RE: Revised Application Deficiency Report #4 - Certificate of Public Convenience and Necessity for the Riverside Transmission Reliability Project – Application No. A.15-04-013

DEFICIENCY REPORT #4 (REVISED) FOR THE RIVERSIDE TRANSMISSION RELIABILITY PROJECT APPLICATION (A. 15-04-013)

Table 1: SCE Riverside Transmission Reliability Project Application 15-04-013 Deficiency Report #4 (Revised 09/22/2016)

MAPBOOK SET ILLUSTRATING CONFLICTS WITH PROPOSED WORK AREAS SOUTHEAST OF THE SANTA ANA RIVER

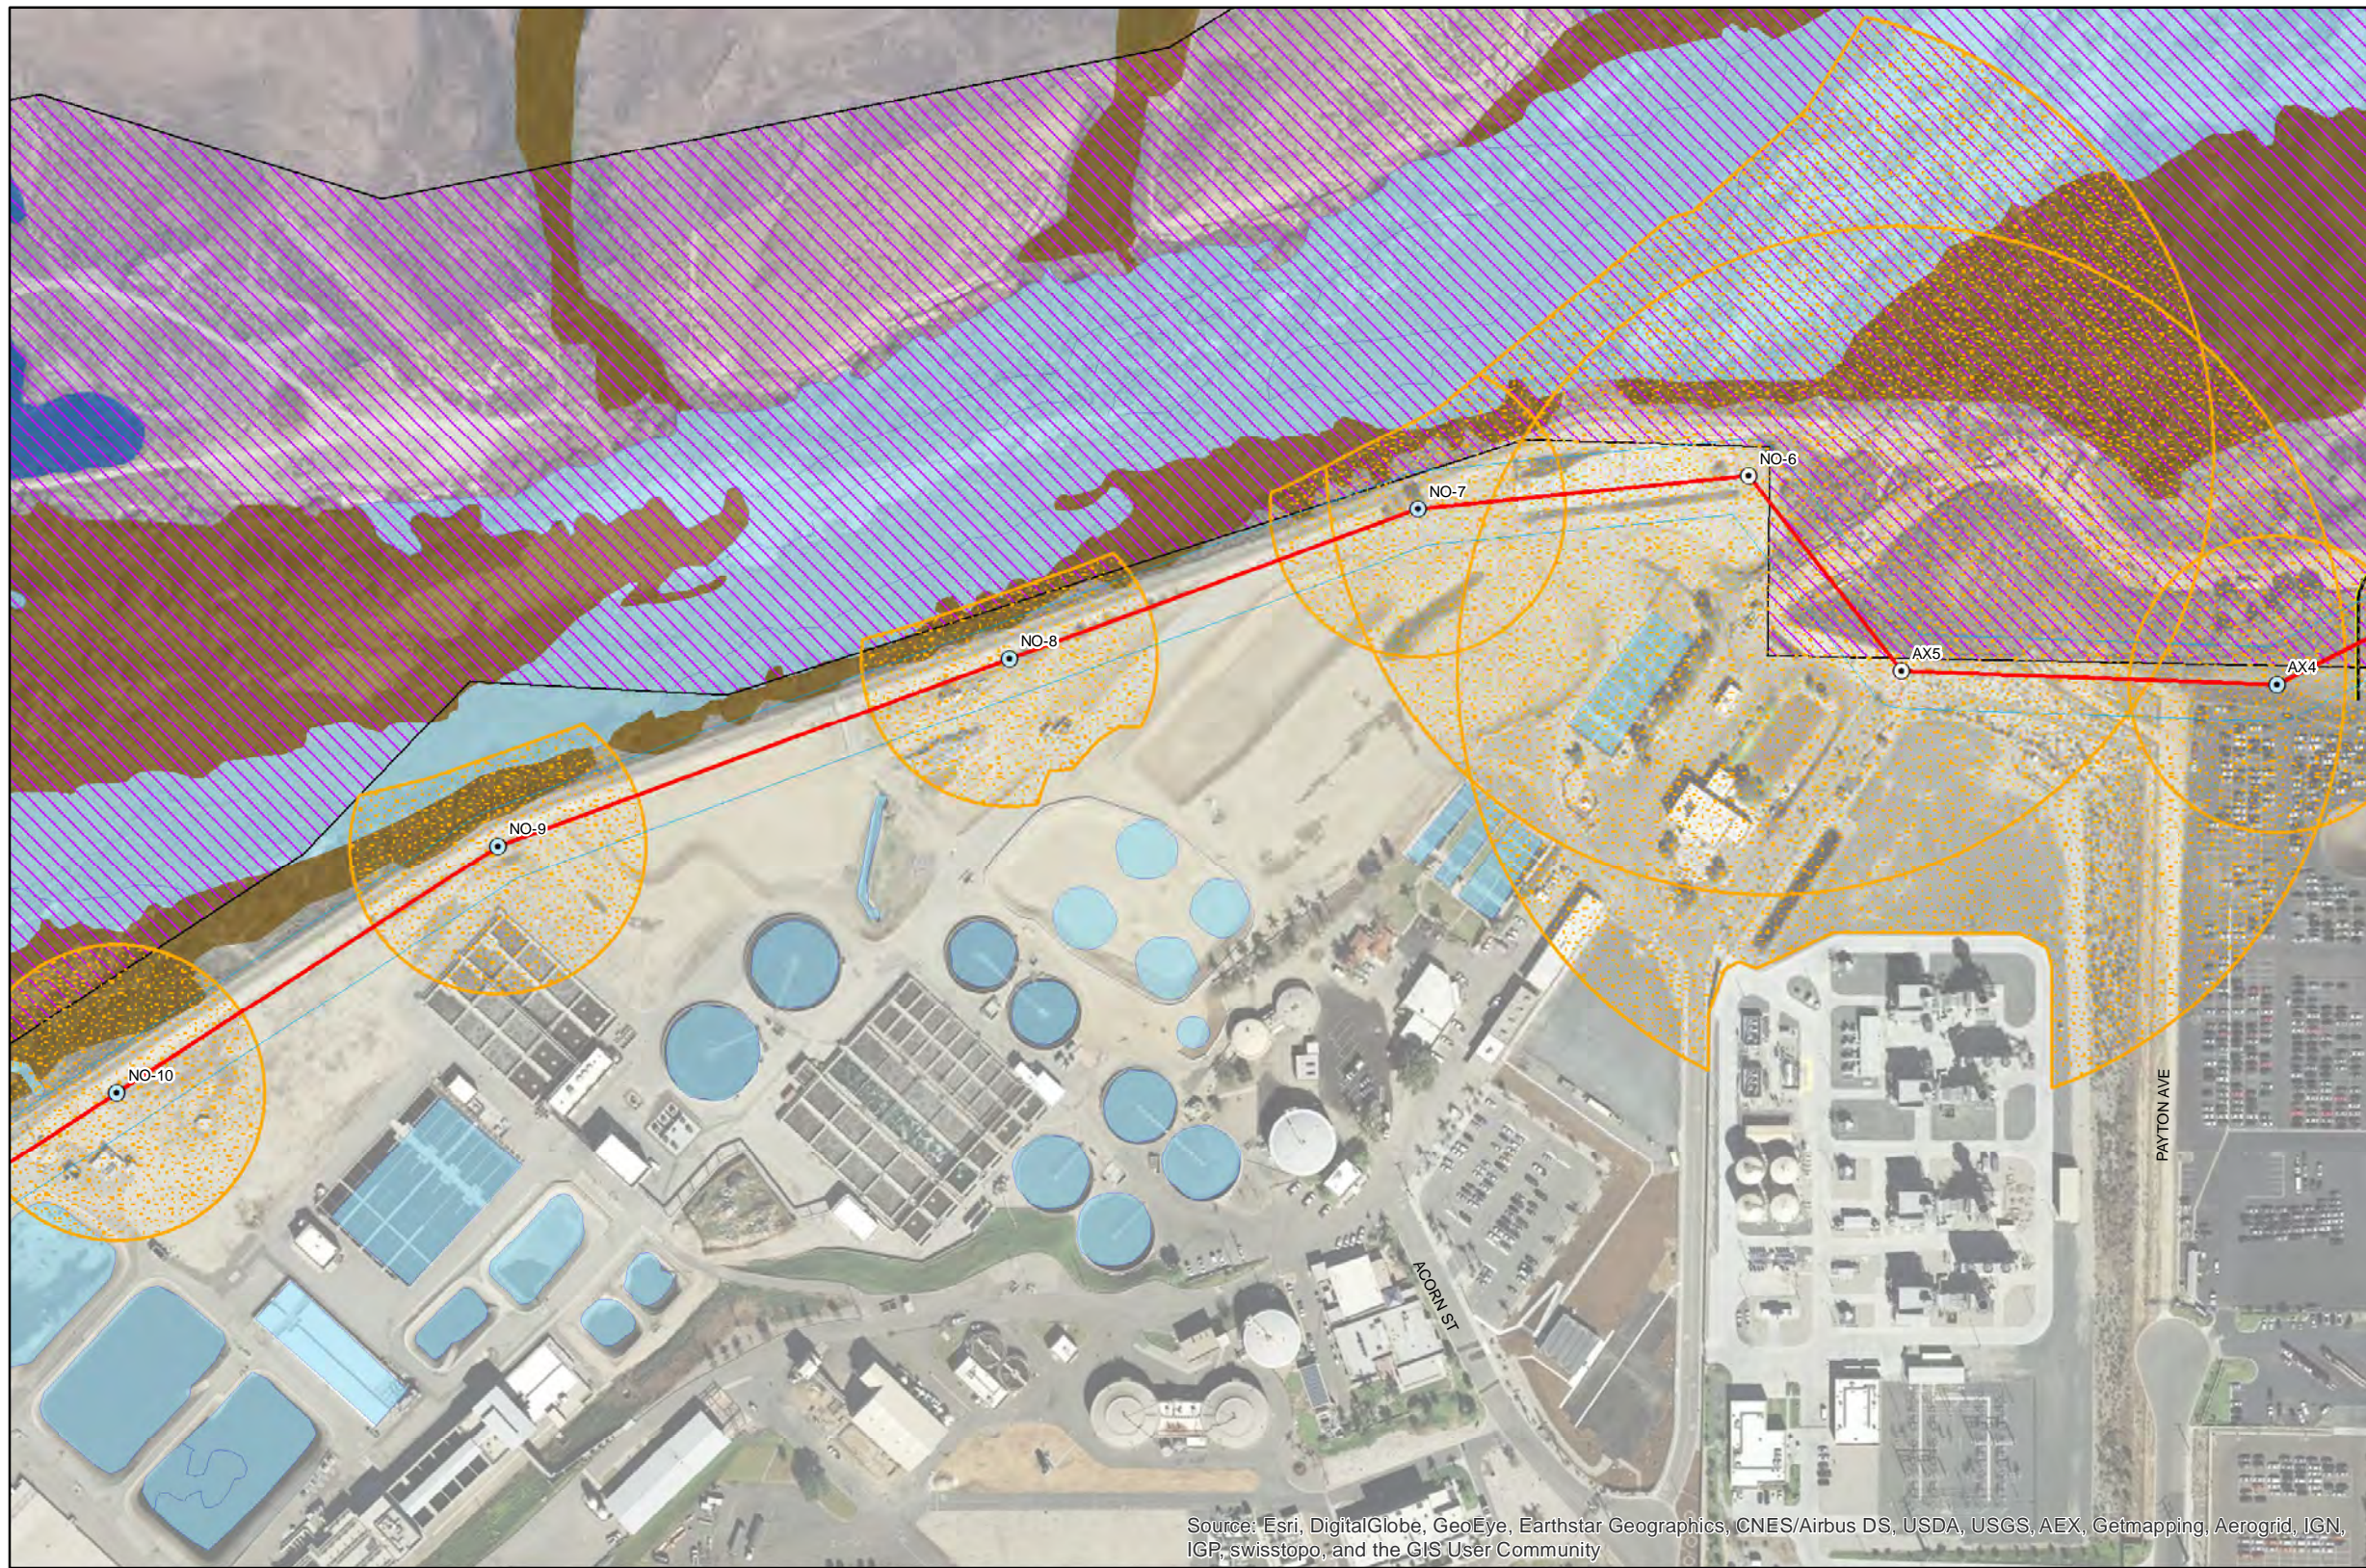
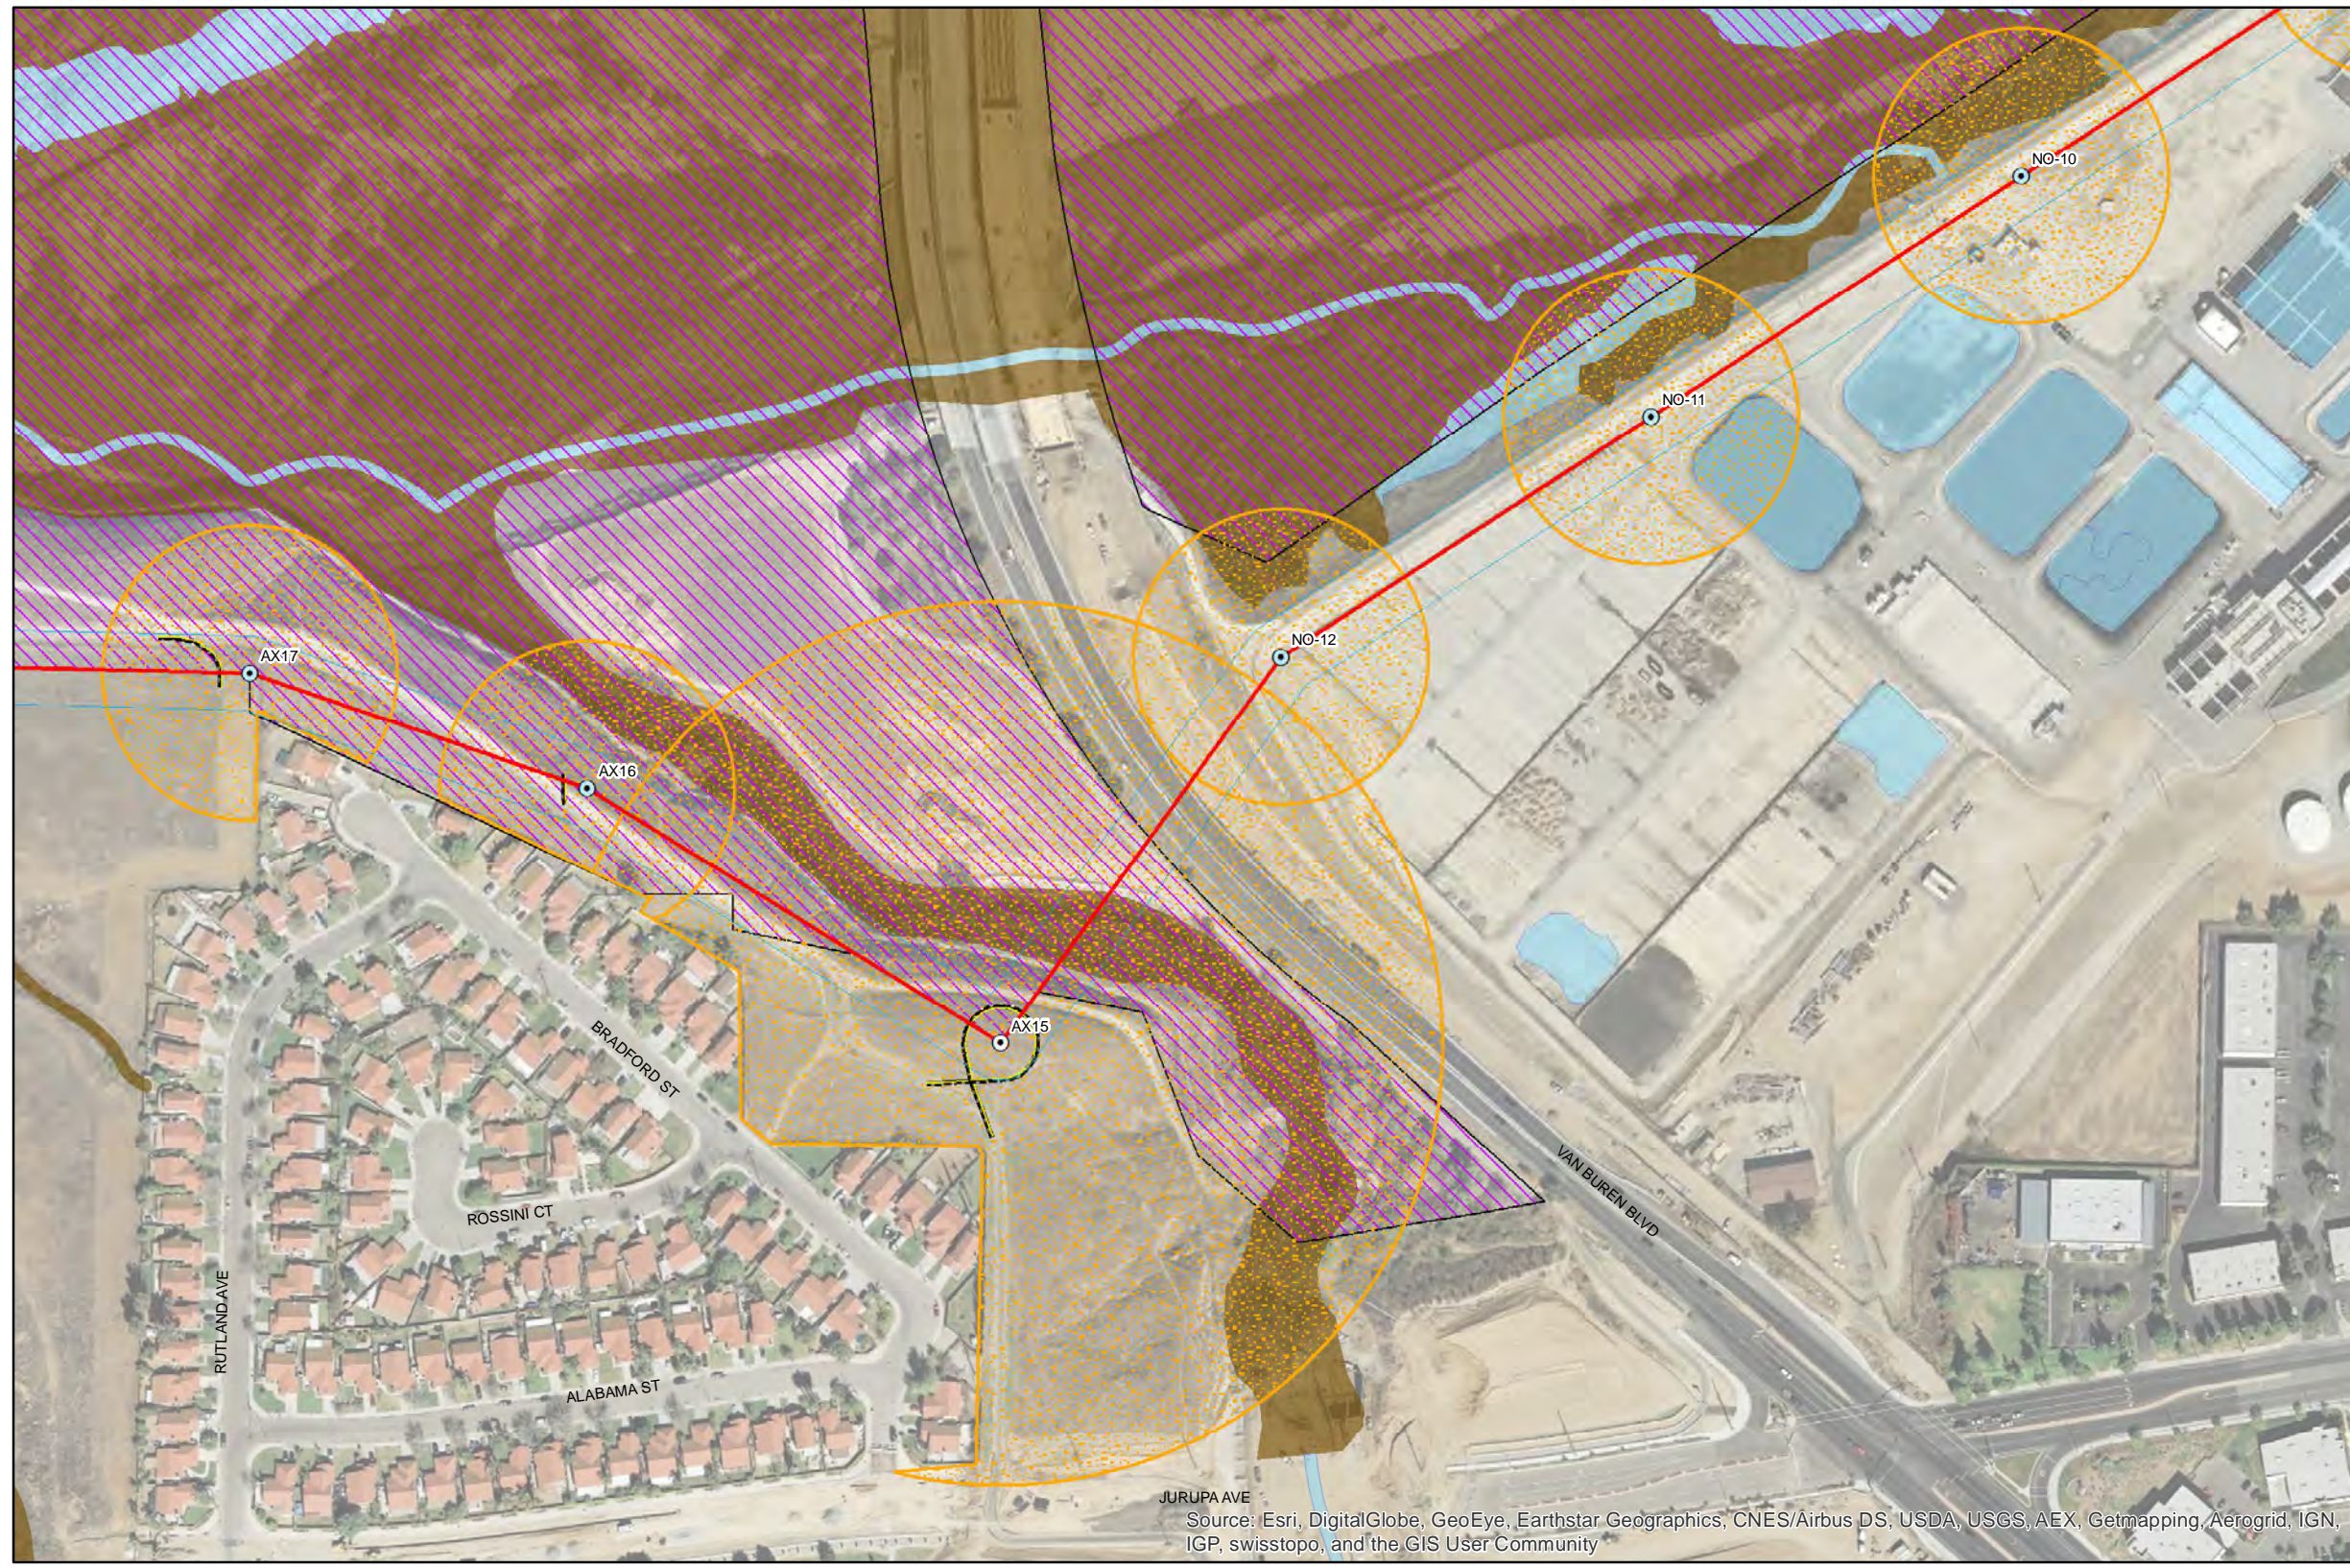
Number	Information Requested Previously?	Deficiency
		<p>The CPUC has prepared a mapbook (Attachment A) showing locations where the proposed buffer areas overlap with the following facilities and resources within the overhead alignment southeast of the Santa Ana River:</p> <ul style="list-style-type: none"> • Steep slopes • Wetlands including the Santa Ana River floodplain and/or tributary drainages • Metropolitan Water District's aqueduct infrastructure • City streets, parking lots, loading/receiving docks, and perimeter landscaping of adjacent buildings • Riverside Water Quality Control Plant facilities • Hidden Valley Wilderness Area (federal land and water conservation fund area) <p>These resources should be avoided and carved out of the work area buffers, where feasible.</p> <p>The revised preliminary engineering plans and detailed route maps should also depict alignment revisions including the proposed underground alignment along Pats Ranch Road and 68th Street, and revised overhead alignment north of Limonite Avenue.</p> <p>Please include GIS data files for all detailed route map refinements.</p>
